# Access Compliance Report

## Public Rights-of-Way

### (Curb Ramps)

Intersection ID: 43670	Main Street: S_TRYON_ST	Cross Street: CORSICA_FOREST_DR	Location: W
ADA ID: 18176CE7591C	Ramp Type: Perp	Initial Pass/Fail: Fail	Overall Compliance: No
Severity Score: 22.5			
Codes/Mitigation Info/Possible Solution		Field Measurements/Component Compliance

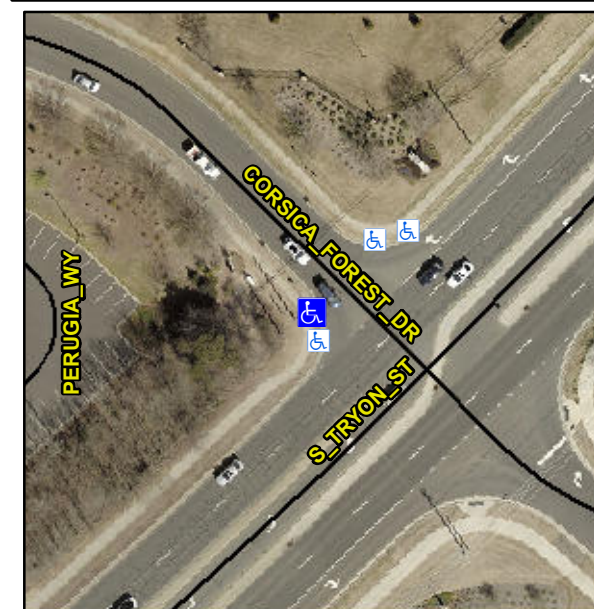
**Not Found, R304.5.1, R304.2.2, R304.5.3**

Compliance	Description	Data	Compliance	Description	Data
N/A	Ramp Length (in)	47.0	No	Ramp Slope (%)	9.5
No	Ramp Width (in)	45.0	No	Ramp XSlope (%)	3.0
N/A	Flare Type LT	N/A	N/A	Flare Type RT	N/A
N/A	Flare Slope LT (%)	N/A	N/A	Flare Slope RT (%)	N/A
N/A	Flare Traversable LT?	N/A	N/A	Flare Traversable RT?	N/A
N/A	Landing Length (in)	N/A	N/A	DWS Provided?	N/A
N/A	Landing Width (in)	N/A	N/A	DWS Contrast?	N/A
N/A	Landing Slope (%)	N/A	N/A	DWS Length (in)	N/A
N/A	Landing X Slope (%)	N/A	N/A	DWS Full Width?	N/A
N/A	Landing Curb? (Y/N)	N/A	N/A	DWS Offset (in)	N/A
N/A	Shared Landing?	N/A			
N/A	Gutter Ponding?	N/A	N/A	Gutter Slope (%)	N/A
N/A	Gutter Lip Ht (in)	N/A	N/A	Gutter X Slope (%)	N/A
N/A	Painted X Walk1?	No	N/A	Painted X Walk2?	N/A
	X Walk 1 Direction	To NE		X Walk 2 Direction	N/A
N/A	X Walk 1 Width (in)	N/A	N/A	X Walk 2 Width (in)	N/A
	X Walk 1 Slope (%)	1.2		X Walk 2 Slope (%)	N/A
	X Walk 1 X Slope (%)	2.0		X Walk 2 X Slope (%)	N/A

**Remove & Replace Entire Ramp.**
